Access Compliance Report

Public Rights-of-Way

Intersection ID: 30487	Main Street: BEDDINGFIELD_DR	Cross Street: EBULLIENT_ST	Location: NE
ADA ID: D57E00D2D815	Ramp Type: PerpDiag	Initial Pass/Fail: Fail	Overall Compliance: No
		Severity Score: 22.5

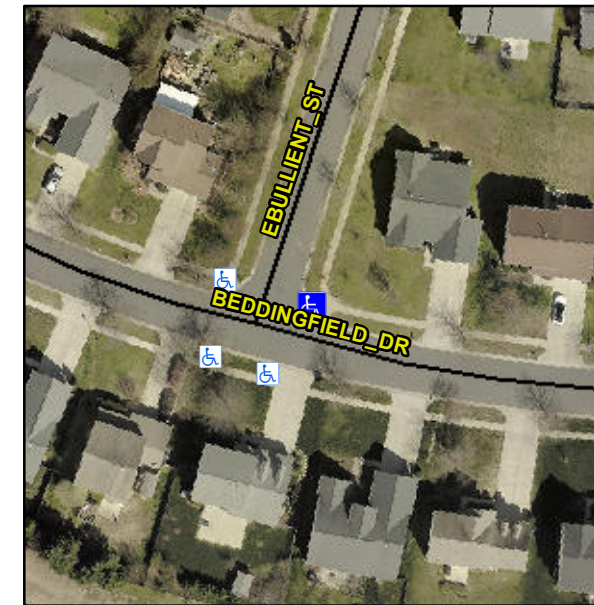
R304.5.1, R304.2.2, R304.5.3

Compliance	Description	Data	Compliance	Description	Data
N/A	Ramp Length (in)	85.0	No	Ramp Slope (%)	9.3
No	Ramp Width (in)	44.0	No	Ramp XSlope (%)	5.0
N/A	Flare Type LT	N/A	N/A	Flare Type RT	N/A
N/A	Flare Slope LT (%)	N/A	N/A	Flare Slope RT (%)	N/A
N/A	Flare Traversable LT?	N/A	N/A	Flare Traversable RT?	N/A
N/A	Landing Length (in)	N/A	N/A	DWS Provided?	N/A
N/A	Landing Width (in)	N/A	N/A	DWS Contrast?	N/A
N/A	Landing Slope (%)	N/A	N/A	DWS Length (in)	N/A
N/A	Landing X Slope (%)	N/A	N/A	DWS Full Width?	N/A
N/A	Landing Curb? (Y/N)	N/A	N/A	DWS Offset (in)	N/A
N/A	Shared Landing?	N/A			
N/A	Gutter Ponding?	N/A	N/A	Gutter Slope (%)	N/A
N/A	Gutter Lip Ht (in)	N/A	N/A	Gutter X Slope (%)	N/A
N/A	Painted X Walk1?	No	N/A	Painted X Walk2?	No
	X Walk 1 Direction	To NW		X Walk 2 Direction	To SW
N/A	X Walk 1 Width (in)	N/A	N/A	X Walk 2 Width (in)	N/A
	X Walk 1 Slope (%)	2.7		X Walk 2 Slope (%)	2.9
	X Walk 1 X Slope (%)	0.3		X Walk 2 X Slope (%)	3.6

Remove & Replace Curb Ramp With Two New Directional Ramps or Equivalent.
